Yarra Planning Scheme Draft Amendment C271yara

Fitzroy and Collingwood Built Form Provisions

Submissions

Figure 3: Proposed Rezoning

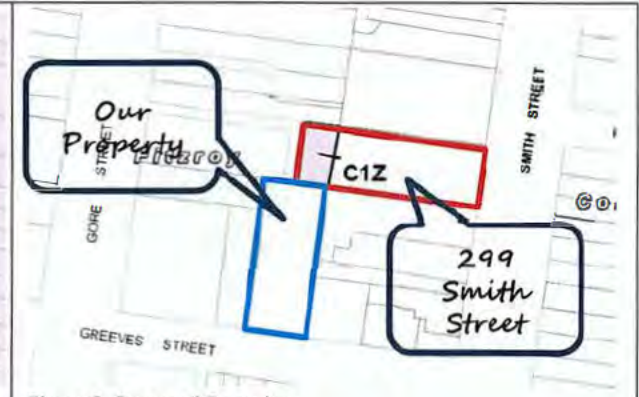
As depicted in Figure 1, below, our property is situated just outside the Smith Street Major Activity Centre (MAC) but abuts several properties that are located within the Activity Centre. While none of the proposed amendments apply directly to our property, its proximity to the MAC means it will undeniably be impacted.

Planning Permit No. PLN20/0743 demonstrated that even a two storey building in the rear portion of 299 Smith Street could have unfavourable impacts on our property. Whilst the proposed DDO30 directs one to have some regard to amenity impacts upon our property it nevertheless allows a built form outcome up to 20.8 metres in height. This allowance will inevitably lead to an obvious conflict between safeguarding our property from inappropriate amenity impacts and realising the full development potential that the DDO30 affords. Retention of the existing NRZ1 zoning and subsequent 'limited opportunity' designation will avoid such conflict and ensure an appropriate outcome is achieved.

Current Heritage Streetwall

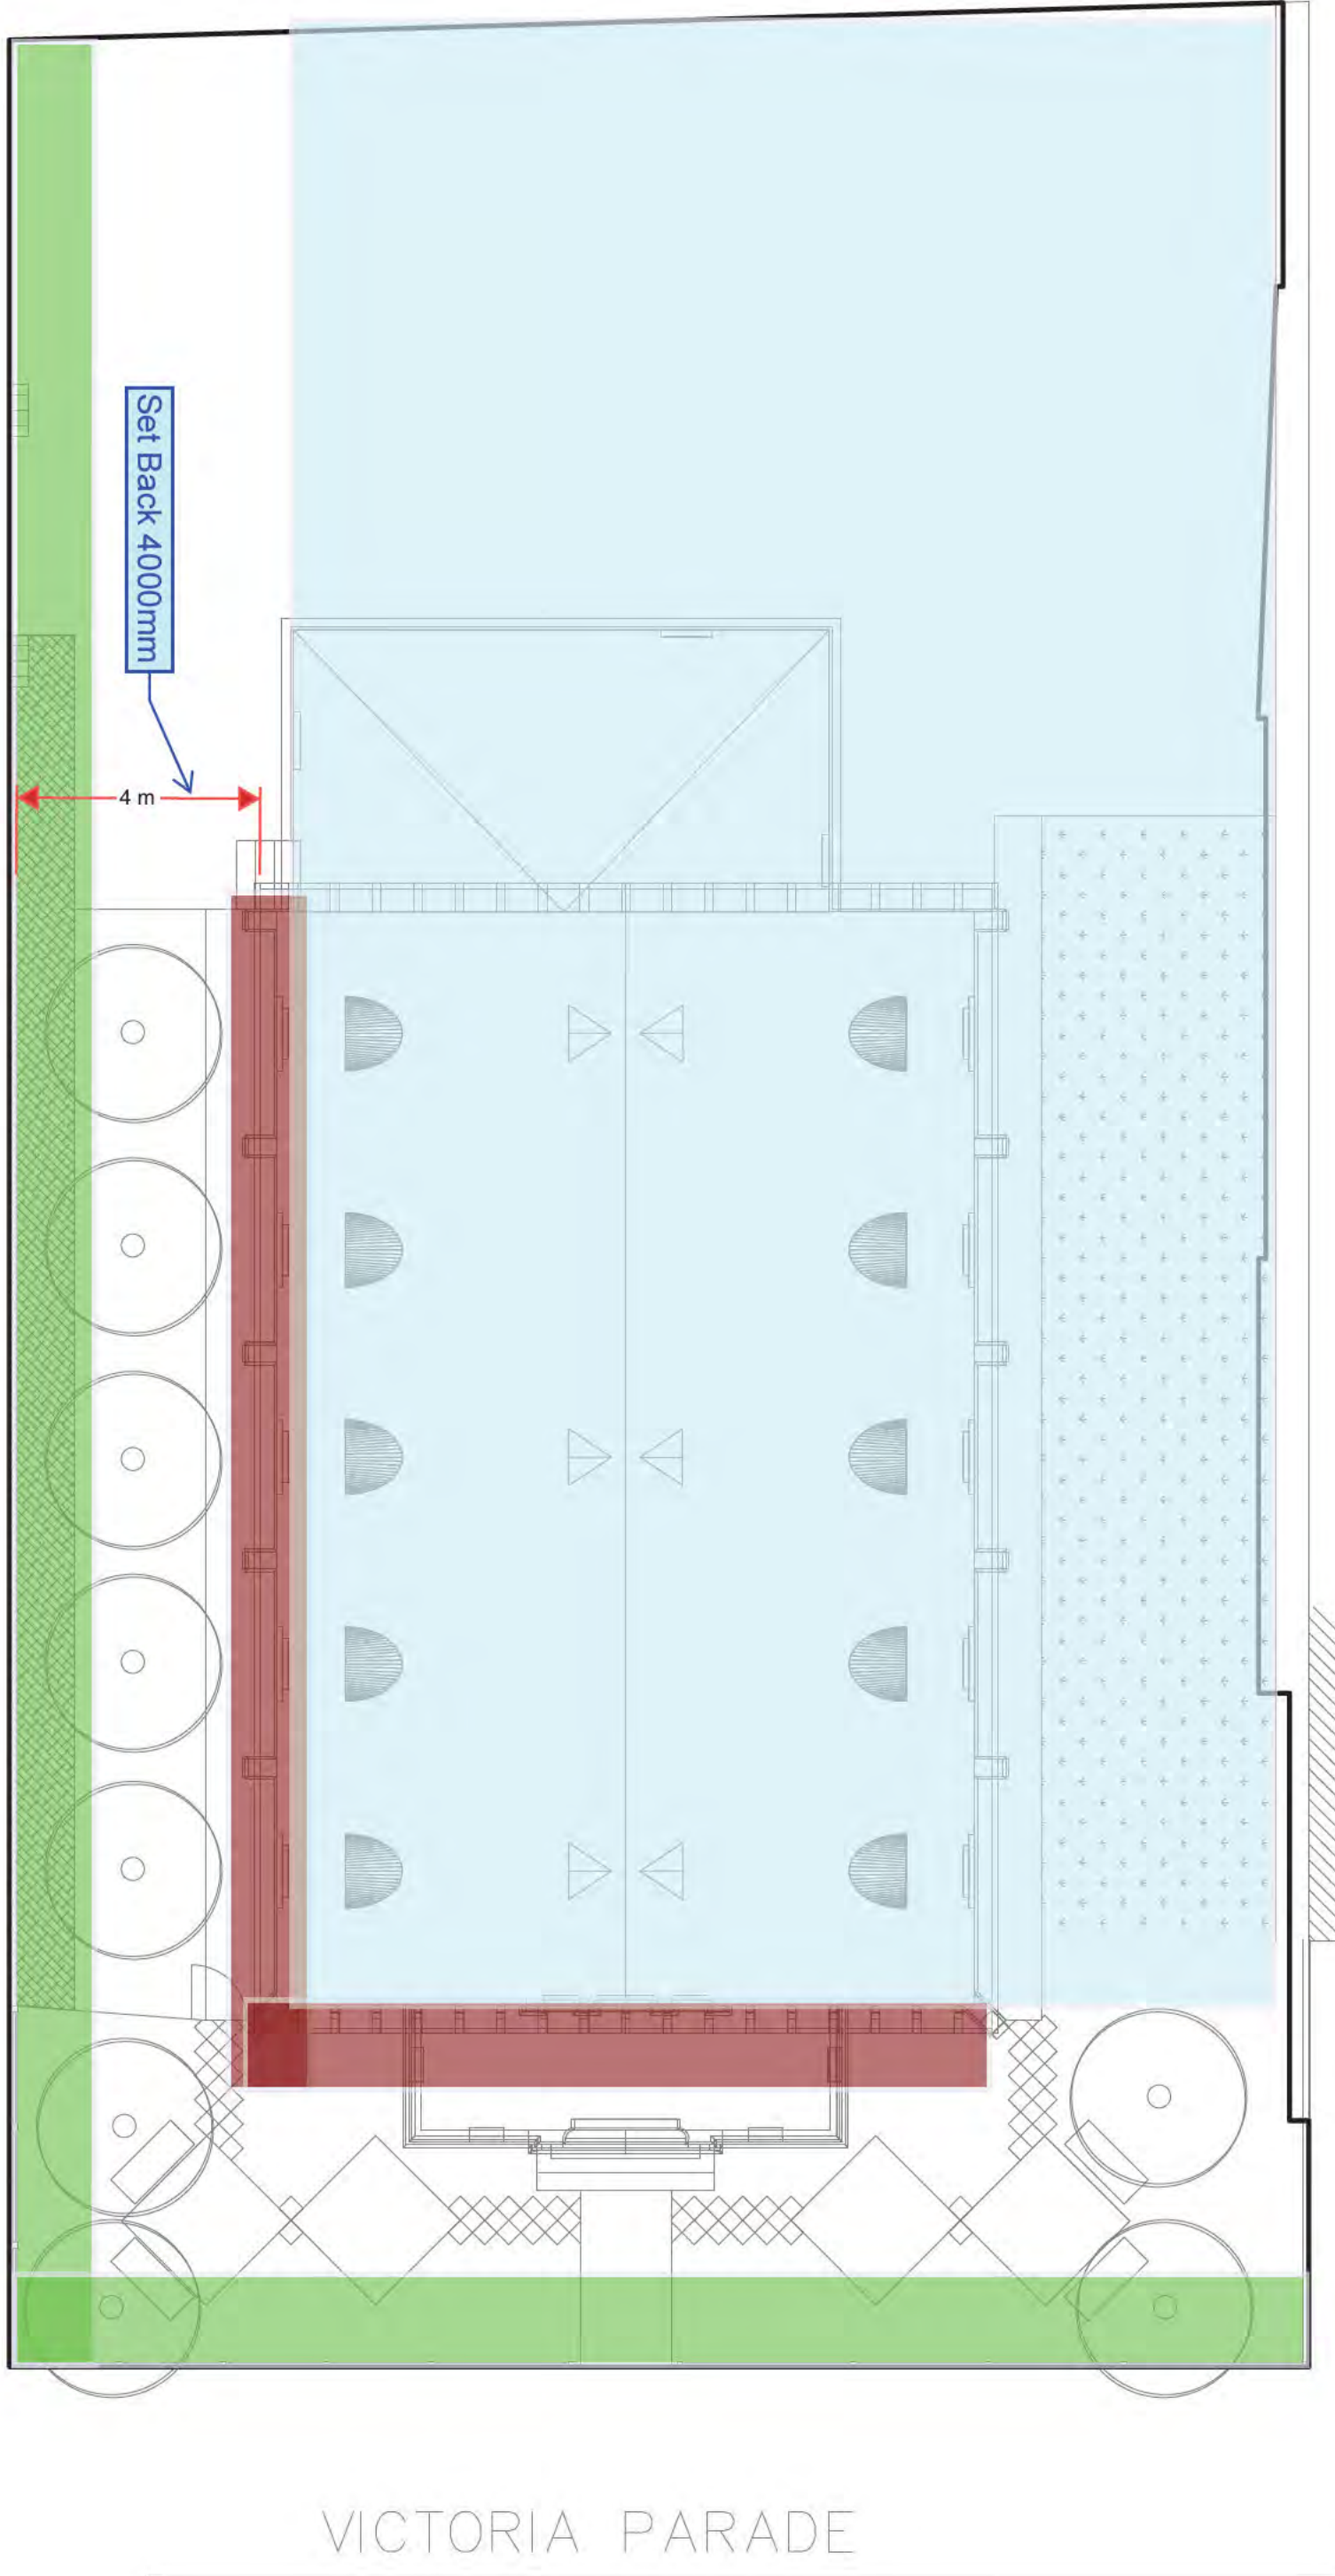
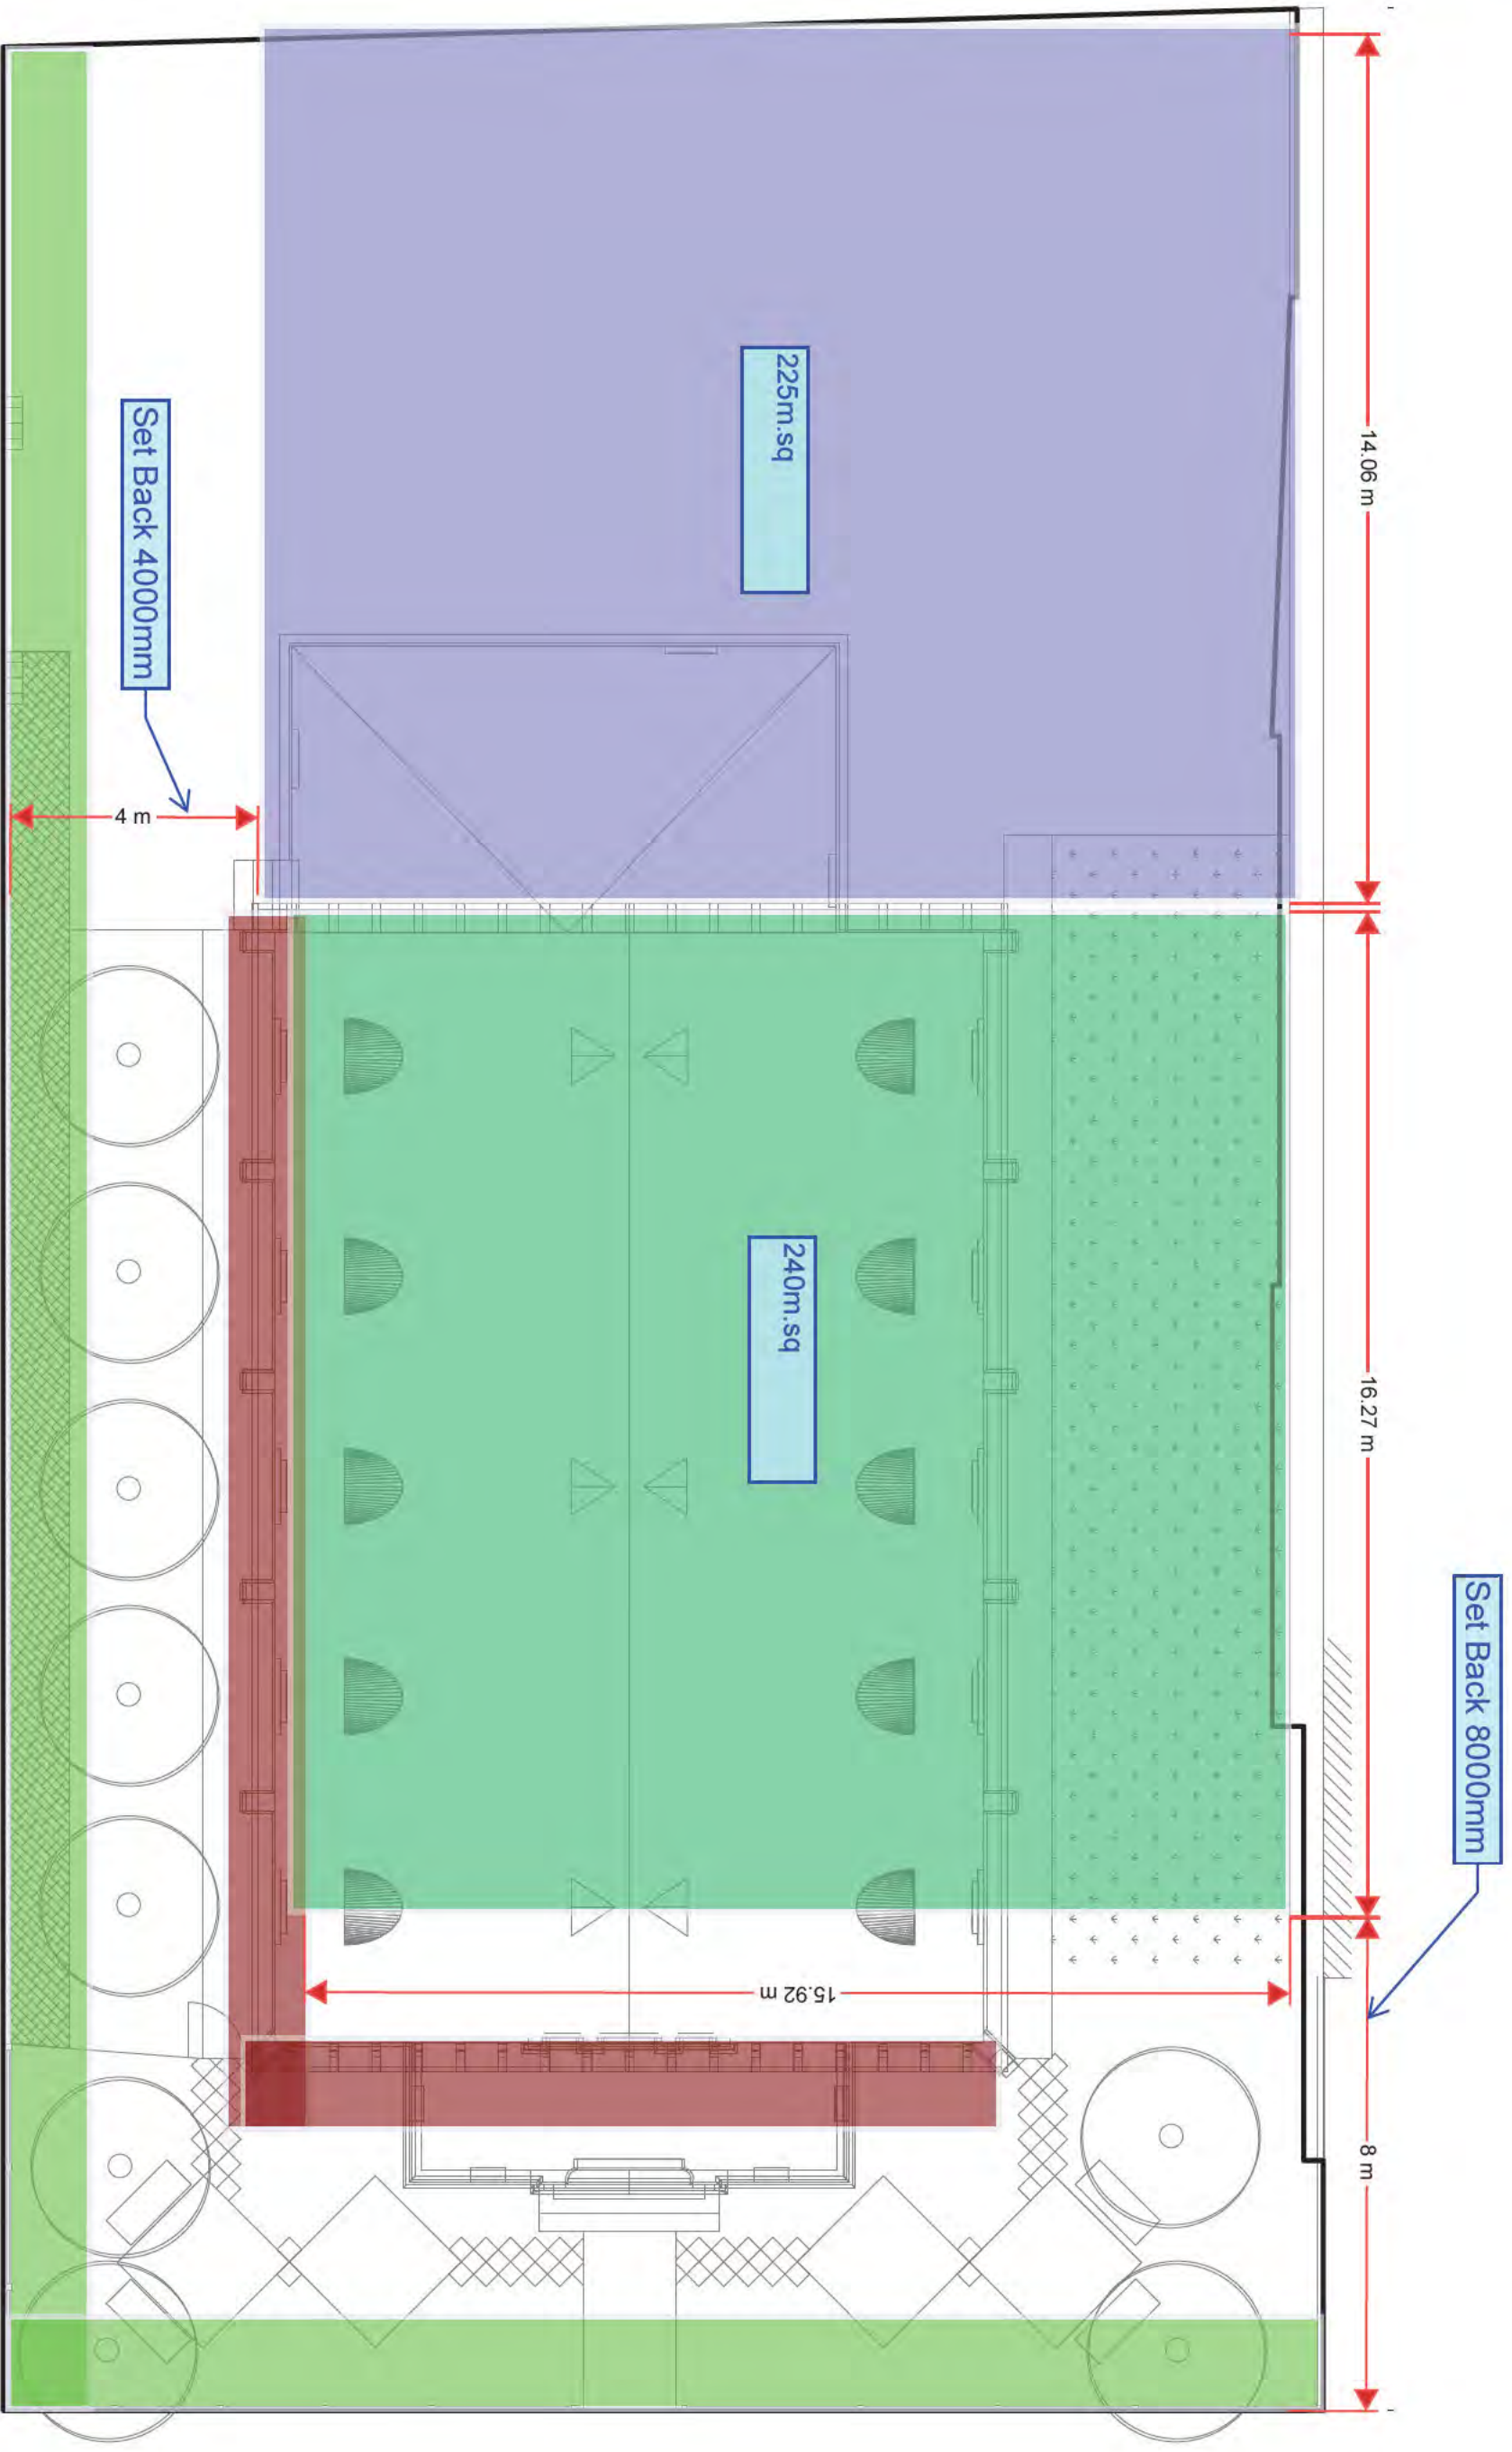
1. **Existing Planning Conditions:** We have attached a plan of the property outlining the existing planning conditions that pertain to setbacks and the preferred maximum building heights.
2. **Proposed Maximum Building Heights:** We have also included our proposed maximum building heights for your review. The plan respects heritage conditions whilst optimising use of less sensitive parts of the site.

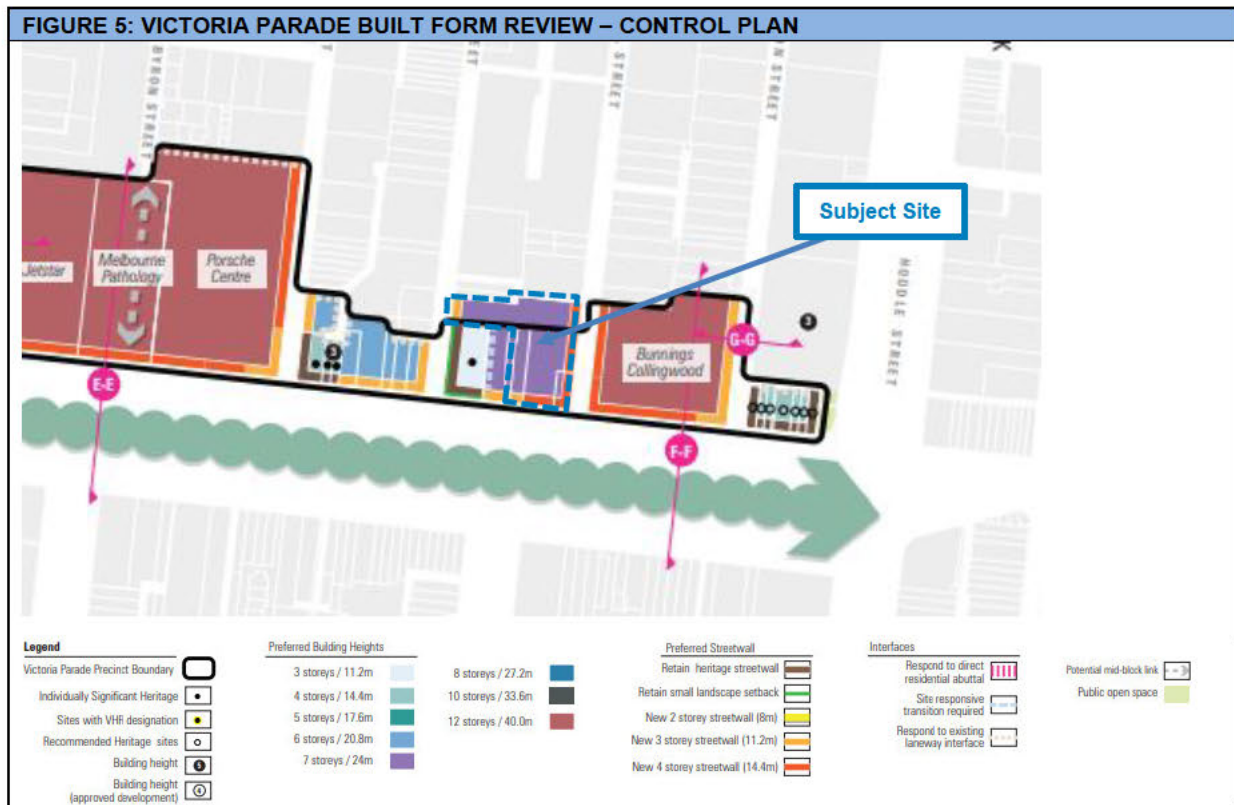
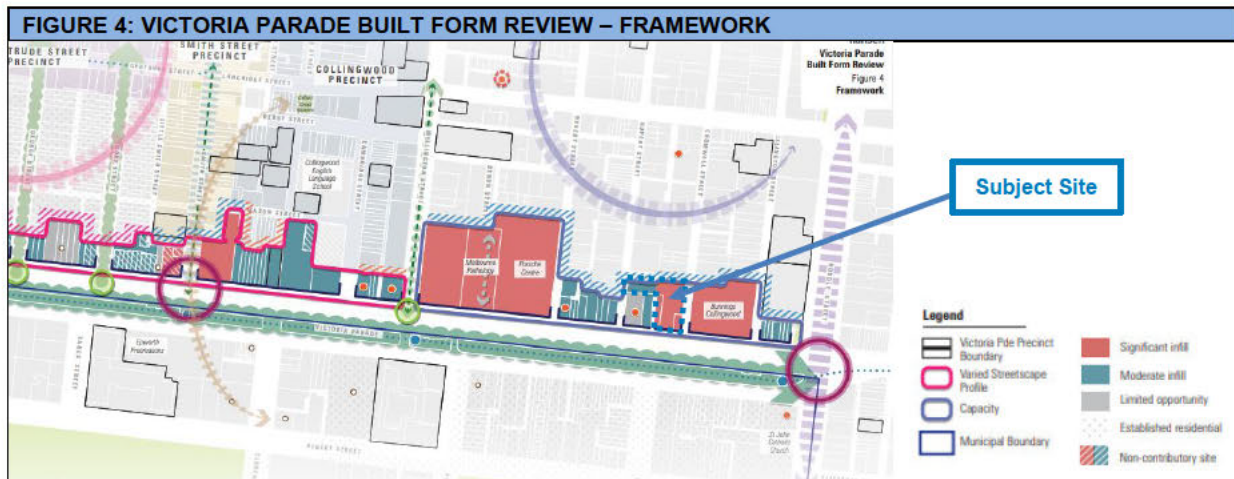
As outlined above, 169-175 Victoria Parade, Lot 1 on TP 814423U is currently dual-zoned, with an arbitrary line bisecting the parcel into separate zones (C1Z and C2Z). A zoning definition plan is provided below at **Figure 3**.

- The parcel is in single ownership.
- There is no statutory reasoning as to why the parcel is dual zoned.
- The bisection of the parcel into dual zones significantly encumbers the built form and land use opportunities for the site.
- The 'depth' of the C1Z from Victoria Parade would be consistent with nearby properties within the activity centre (thereby, eliminating the perception of 'creep').
- The site does not adjoin residentially zoned land.
- 15 zoning anomaly corrections of similar context are also proposed as part of Amendment C271, and therefore this anomaly can be corrected simultaneously.

- The background documentation, Victoria Parade Built Form Framework, prepared by Hansen Partnership also incorrectly (and inconsistently) categorises the sites boundaries / built form possibilities. Specifically,
 - The Built Form Review includes the entire site within the “Capacity” boundary and nominates two separate infill outcomes for the site (which are also inconsistent with the title boundary configurations). See Figure 4.
 - The Control Plan excludes a portion of the site outside the “Victoria Parade Precinct Boundary”, but includes a preferred built form outcome for the excluded portion. See Figure 5.

Figure 1 – Victoria Parade indicative cross section

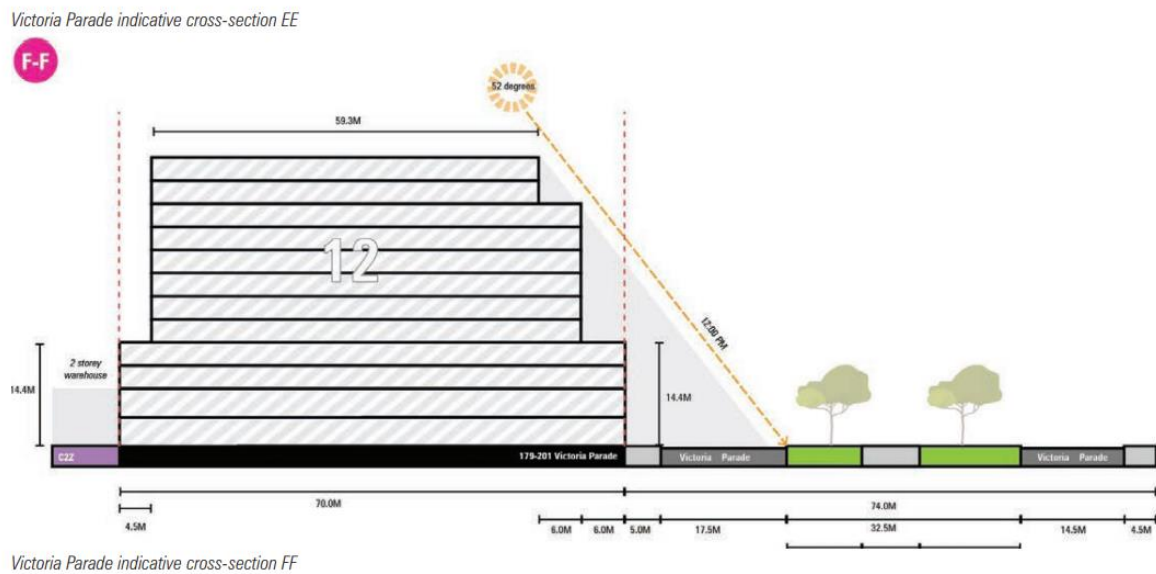
The cross section 'F-F' prepared demonstrates that this principle can be met by applying a 12 storey building height at the subject land. See Figure 1 below.

Figure 1 – Victoria Parade indicative cross section

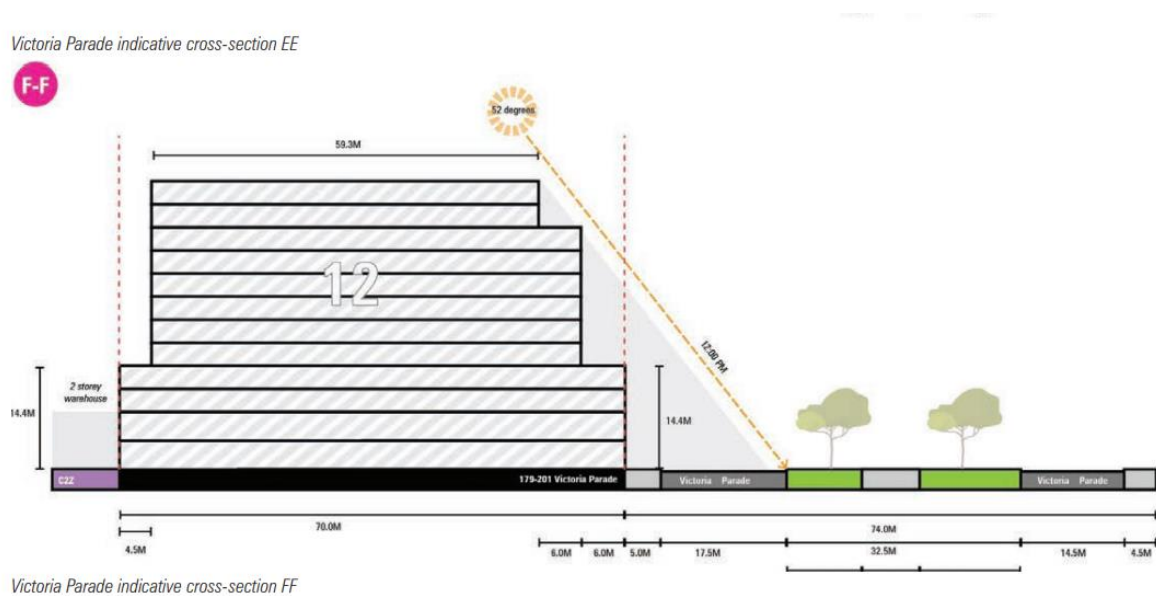
The cross section 'F-F' (Figure 1) demonstrates that this principle can be met by applying a 12 storey building height at the subject land.

The below cross section has been relied on to justify height controls only 30 metres to the west of the subject land at the Bunnings site, there is no clear rationale as to why the 12 storey height has not been equally applied to the subject land.
